Service Letter No. 505A
(Supersedes Service Letter No. 505)

Fuselage Drain Holes

PA-31 Navajo

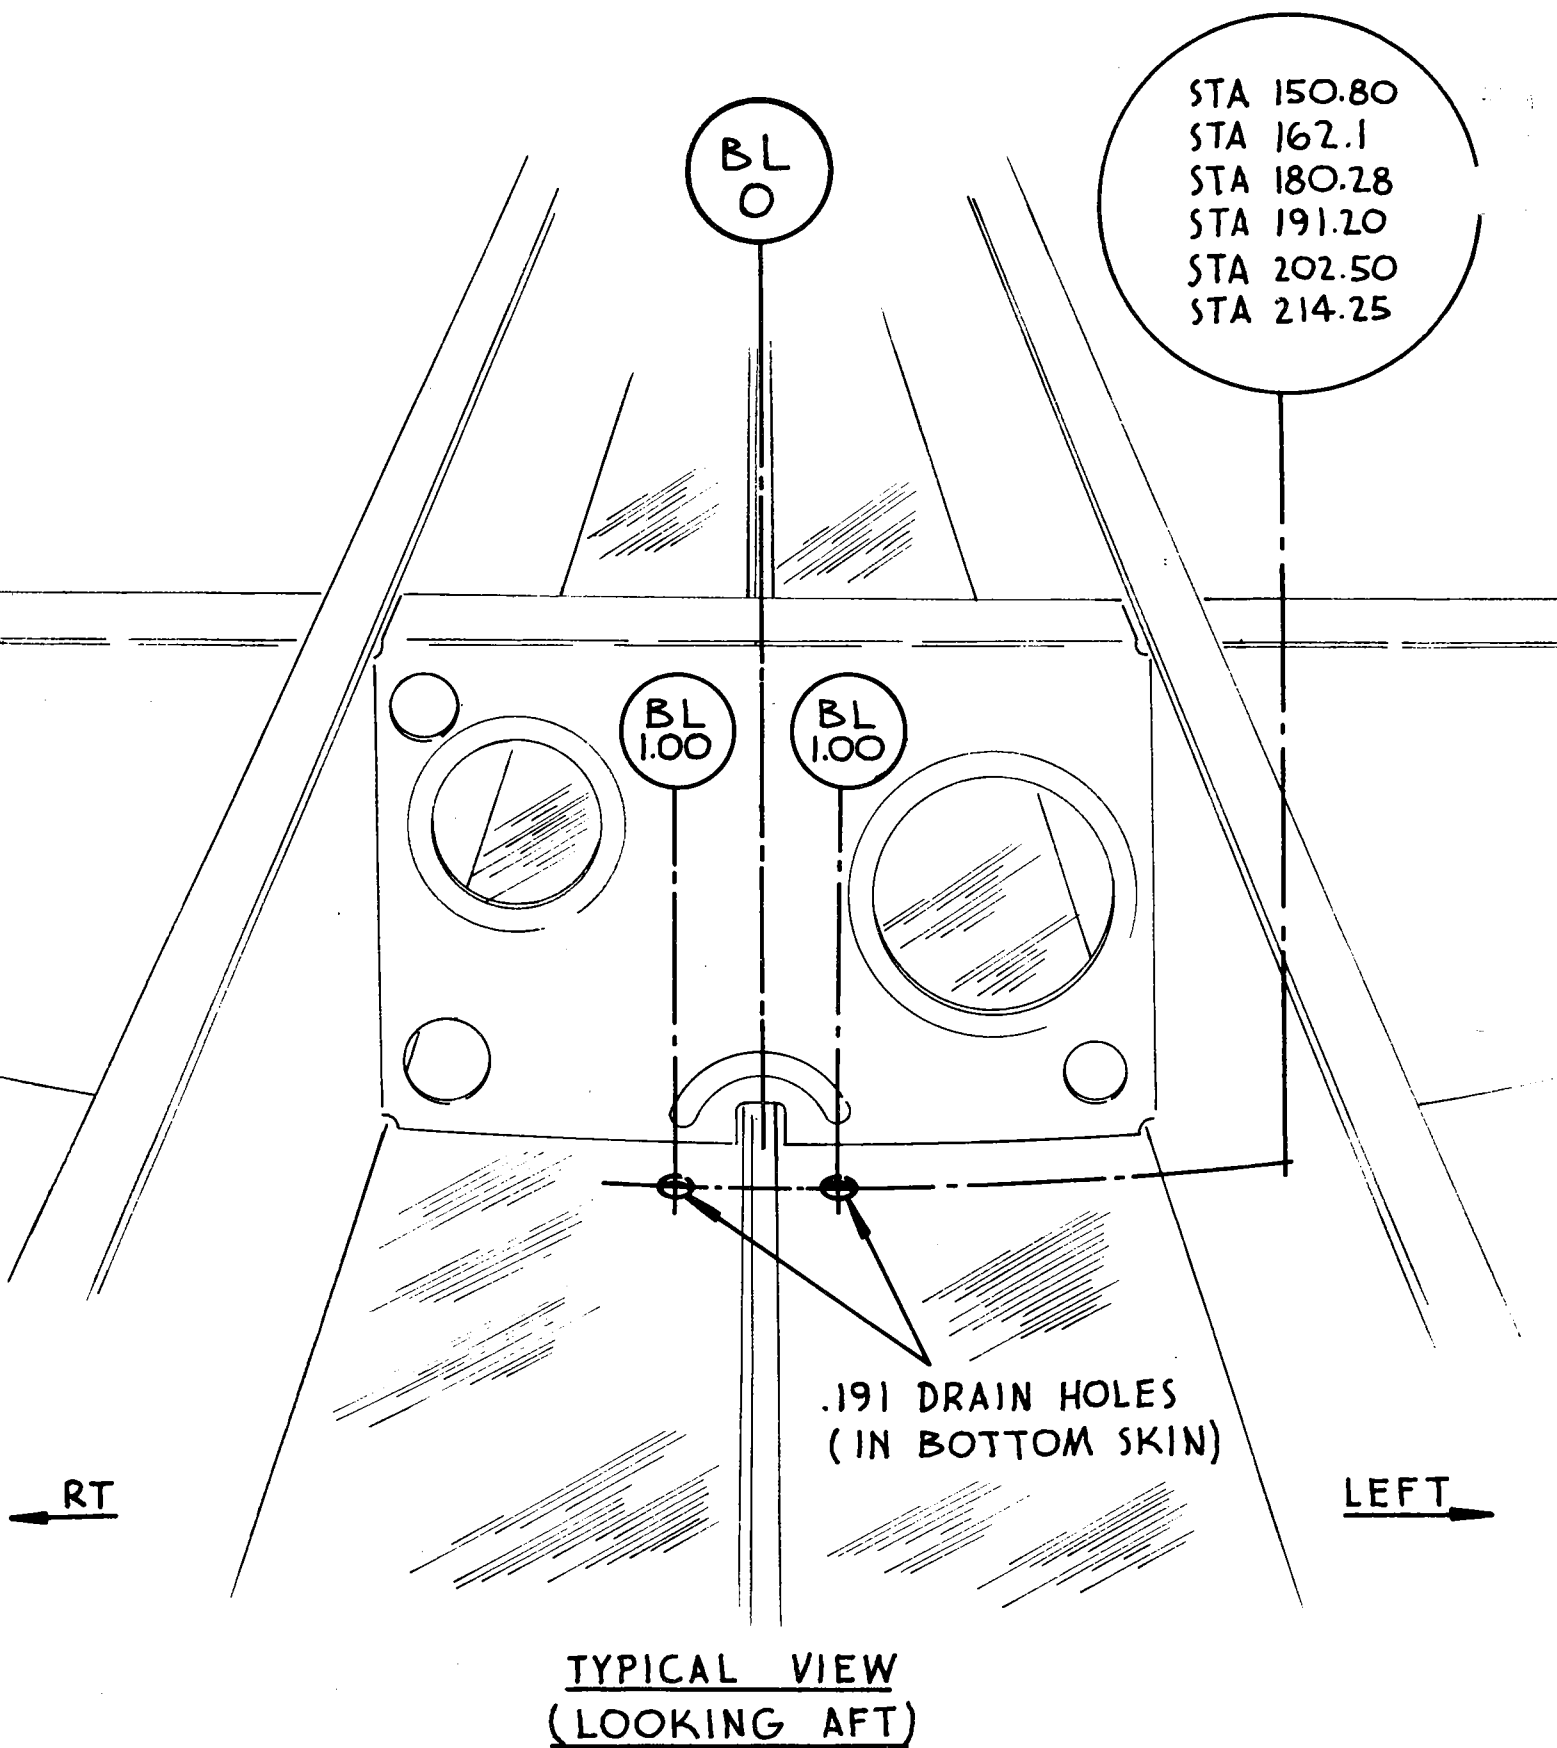
To provide drain holes at various fuselage locations.

Each hole must be drilled .191 inches in size. The proper hole locations are depicted on the reverse side of this letter.

It is recommended that this modification be accomplished at the next one-hundred (100) hour inspection, when the floorboards are removed, to insure that airframe members are not damaged during the drilling process.
